Access Compliance Report

Public Rights-of-Way

(Island Curb Cuts)

Intersection ID: 16151	Main Street: FREELAND_LN	Cross Street: S_TRYON_ST	Location: SW
ADA ID: 7A38D31C2FE7	Curb Cut Type: MedianRefuge2	Initial Pass/Fail: Fail	Overall Compliance: No
Codes/Mitigation Info/Possible Solution		Field Measurements/Component Compliance	
Severity Score: 0

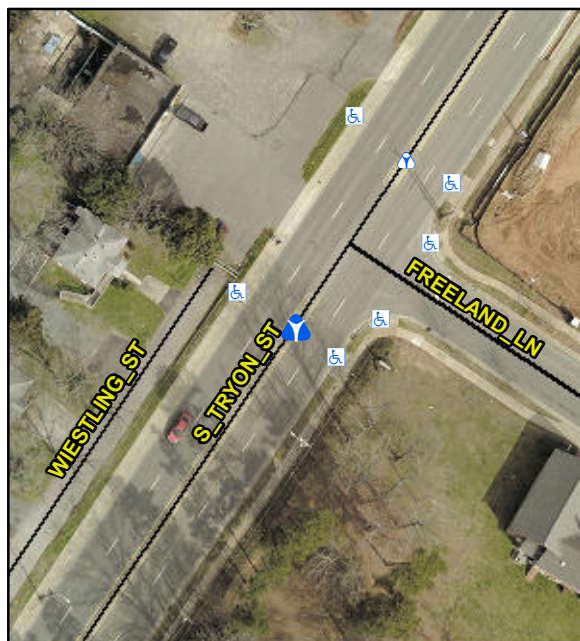
Compliance	Description	Data	Compliance	Description	Data
No	Refuge 1 Length (In)	31.0	N/A	Gutter 1 Ponding?	N/A
Yes	Refuge 1 Width (In)	122.0	N/A	Gutter 1 Lip Ht (In)	N/A
Yes	Refuge 1 Slope (%)	0.3	N/A	Gutter 1 Slope (%)	N/A
Yes	Refuge 1 X Slope (%)	2.6	N/A	Gutter 1 X Slope (%)	N/A
N/A	Painted X Walk1?	No	N/A	DWS 1 Provided?	N/A
N/A	X Walk 1 Direction	To SE	N/A	DWS 1 Contrast?	N/A
N/A	X Walk 1 Width (In)	N/A	N/A	DWS 1 Length (In)	N/A
N/A	Road 1 Slope (%)	3.6	N/A	DWS 1 Full Width?	N/A
N/A	Road 1 X Slope (%)	3.9	N/A	DWS 1 Offset (In)	N/A
No	Refuge 2 Length (In)	31.0	N/A	Gutter 2 Ponding?	N/A
Yes	Refuge 2 Width (In)	122.0	N/A	Gutter 2 Lip Ht (In)	N/A
Yes	Refuge 2 Slope (%)	1.9	N/A	Gutter 2 Slope (%)	N/A
Yes	Refuge 2 X Slope (%)	1.6	N/A	Gutter 2 X Slope (%)	N/A
N/A	Painted X Walk2?	No	N/A	DWS 2 Provided?	N/A
N/A	X Walk 2 Direction	To NW	N/A	DWS 2 Contrast?	N/A
N/A	X Walk 2 Width (In)	N/A	N/A	DWS 2 Length (In)	N/A

Remove & Replace Entire Refuge.
